CERTAIN 2005 THROUGH 2006 MODEL YEAR F-150 VEHICLES BUILT AT NORFOLK ASSEMBLY PLANT — CLOCKSPrING TO DRIVER SIDE FRONTAL AIR BAG WIRE HARNESS REPLACEMENT

FIGURE 1

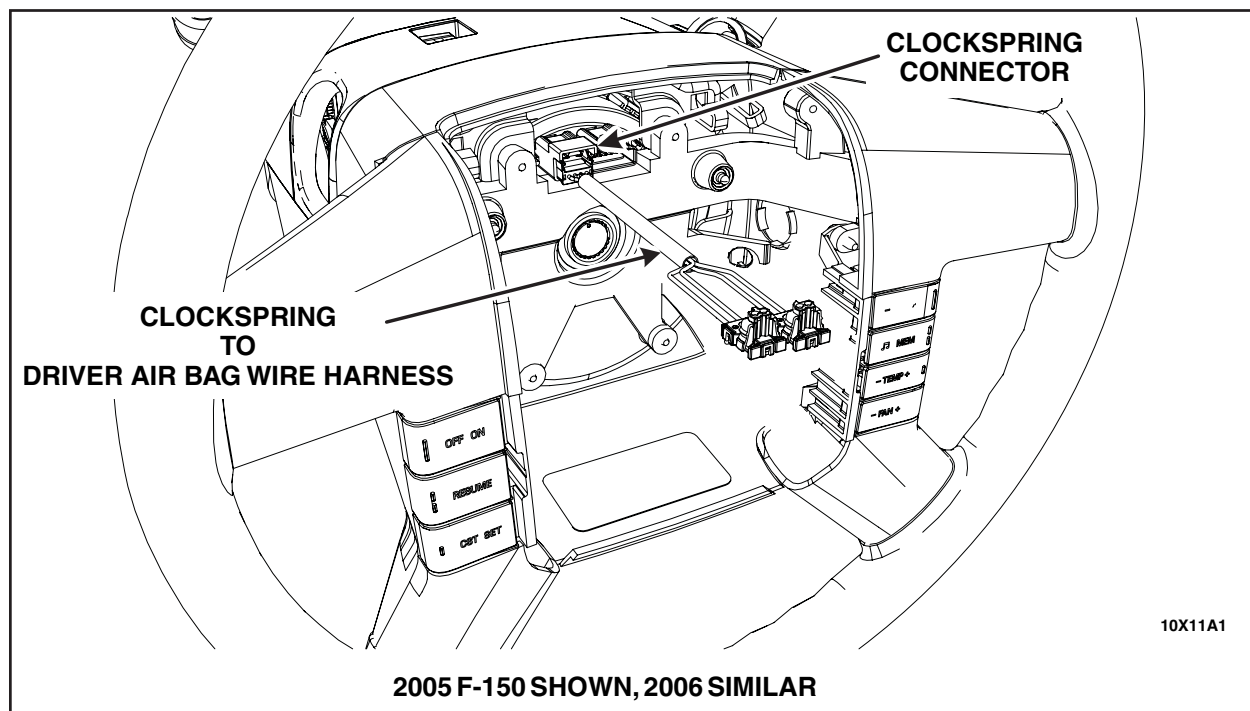
On some of the affected vehicles, it may be possible for the clockspring to driver side frontal air bag wire harness to chafe on the horn mounting plate. This may cause the air bag warning lamp to illuminate in the cluster indicating service is required. If the air bag warning lamp is ignored, this chafing may cause the driver side frontal air bag to inadvertently deploy and may result in personal injury. Dealers are to replace the clockspring to driver side frontal air bag wire harness with a service part that incorporates additional chafe protection.

1. Remove the driver air bag. For additional information, refer to the appropriate WSM, Section 501-20B.
2. Release the clockspring connector lock and disconnect the harness from the clockspring. See Figure 1.

3. Install the **new** clockspring to driver air bag wire harness using the following sequence:
 1. Connect the harness to the clockspring.
 2. Make sure the harness lock at the clockspring is seated.
 3. Connect the harness to the air bag.
4. Install the driver air bag. For additional information, refer to the appropriate WSM, Section 501-20B.
